# Access Compliance Report

## Public Rights-of-Way

Intersection ID: 32311	Main Street: LAUREL_WALK_CT	Cross Street: NEW_PROVIDENCE_LN	Location: SE
ADA ID: C0C92803E8F4	Ramp Type: Perp	Initial Pass/Fail: Fail	Overall Compliance: No
Severity Score: 21.25			
Codes/Mitigation Info/Possible Solution		Field Measurements/Component Compliance

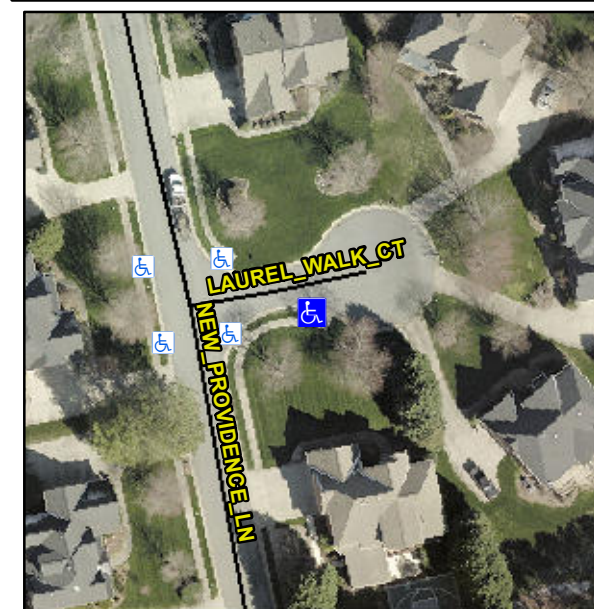
**R304.5.1, R304.2.2**

Compliance	Description	Data	Compliance	Description	Data
N/A	Ramp Length (in)	47.5	No	Ramp Slope (%)	8.6
No	Ramp Width (in)	42.0	Yes	Ramp XSlope (%)	1.2
N/A	Flare Type LT	N/A	N/A	Flare Type RT	N/A
N/A	Flare Slope LT (%)	N/A	N/A	Flare Slope RT (%)	N/A
N/A	Flare Traversable LT?	N/A	N/A	Flare Traversable RT?	N/A
N/A	Landing Length (in)	N/A	N/A	DWS Provided?	N/A
N/A	Landing Width (in)	N/A	N/A	DWS Contrast?	N/A
N/A	Landing Slope (%)	N/A	N/A	DWS Length (in)	N/A
N/A	Landing X Slope (%)	N/A	N/A	DWS Full Width?	N/A
N/A	Landing Curb? (Y/N)	N/A	N/A	DWS Offset (in)	N/A
N/A	Shared Landing?	N/A			
N/A	Gutter Ponding?	N/A	N/A	Gutter Slope (%)	N/A
N/A	Gutter Lip Ht (in)	N/A	N/A	Gutter X Slope (%)	N/A
N/A	Painted X Walk1?	No	N/A	Painted X Walk2?	N/A
	X Walk 1 Direction	To N		X Walk 2 Direction	N/A
N/A	X Walk 1 Width (in)	N/A	N/A	X Walk 2 Width (in)	N/A
	X Walk 1 Slope (%)	3.2		X Walk 2 Slope (%)	N/A
	X Walk 1 X Slope (%)	5.0		X Walk 2 X Slope (%)	N/A

**Remove & Replace Entire Ramp.**
